PRODUCT CHANGE NOTIFICATION

PCN-000925

SMF05.TCT

Semtech is updating the Product Datasheet for SMF05.TCT.

Outline Drawing - SC70 5L

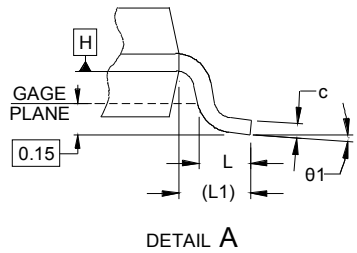
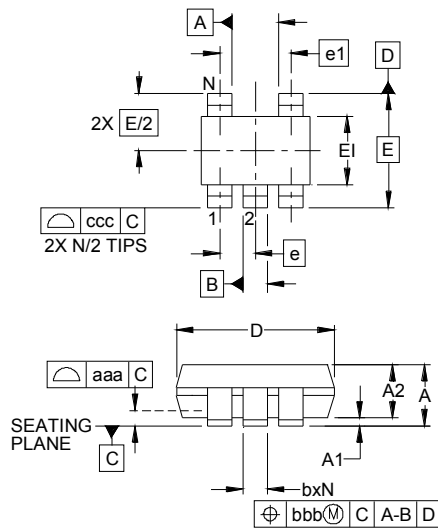
From							To						
DIMENSIONS							DIMENSIONS						
DIM	INCHES			MILLIMETERS			DIM	INCHES			MILLIMETERS		
	MIN	NOM	MAX	MIN	NOM	MAX		MIN	NOM	MAX	MIN	NOM	MAX
A	-	-	.043	-	-	1.10	A	-	-	.043	-	-	1.10
A1	.000	-	.004	0.00	-	0.10	A1	.000	-	.004	0.00	-	0.10
A2	.028	.035	.039	0.70	0.90	1.00	A2	.028	.035	.039	0.70	0.90	1.00
b	.006	-	.012	0.15	-	0.30	b	.004	-	.012	0.10	-	0.30
c	.003	-	.009	0.08	-	0.22	c	.003	-	.009	0.08	-	0.22
D	.075	.079	.083	1.90	2.00	2.10	D	.071	.079	.087	1.80	2.00	2.20
E1	.045	.049	.053	1.15	1.25	1.35	E1	.045	.049	.053	1.15	1.25	1.35
E	.083 BSC			2.10 BSC			E	.083 BSC			2.10 BSC		
e	.026 BSC			0.65 BSC			e	.026 BSC			0.65 BSC		
e1	.051			1.30 BSC			e1	.051			1.30 BSC		
L	.010	.014	.018	0.26	0.36	0.46	L	.010	.014	.018	0.26	0.36	0.46
L1	(.017)			(0.42)			L1	(.017)			(0.42)		
N	5			5			N	5			5		
θ1	0°	-	8°	0°	-	8°	θ1	0°	-	8°	0°	-	8°
aaa	.004			0.10			aaa	.004			0.10		
bbb	.004			0.10			bbb	.004			0.10

ccc	.012			0.30			ccc	.012			0.30

DIM	INCHES			MILLIMETERS		
	MIN	NOM	MAX	MIN	NOM	MAX
A	-	-	.043	-	-	1.10
A1	.000	-	.004	0.00	-	0.10
A2	.028	.035	.039	0.70	0.90	1.00
b	.004	-	.012	0.10	-	0.30
c	.003	-	.009	0.08	-	0.22
D	.071	.079	.087	1.80	2.00	2.20
E1	.045	.049	.053	1.15	1.25	1.35
E	.083 BSC			2.10 BSC		
e	.026 BSC			0.65 BSC		
e1	.051			1.30 BSC		
L	.010	.014	.018	0.26	0.36	0.46
L1	(.017)			(0.42)		
N	5			5		
01	0°	-	8°	0°	-	8°
aaa	.004			0.10		
bbb	.004			0.10		
ccc	.012			0.30
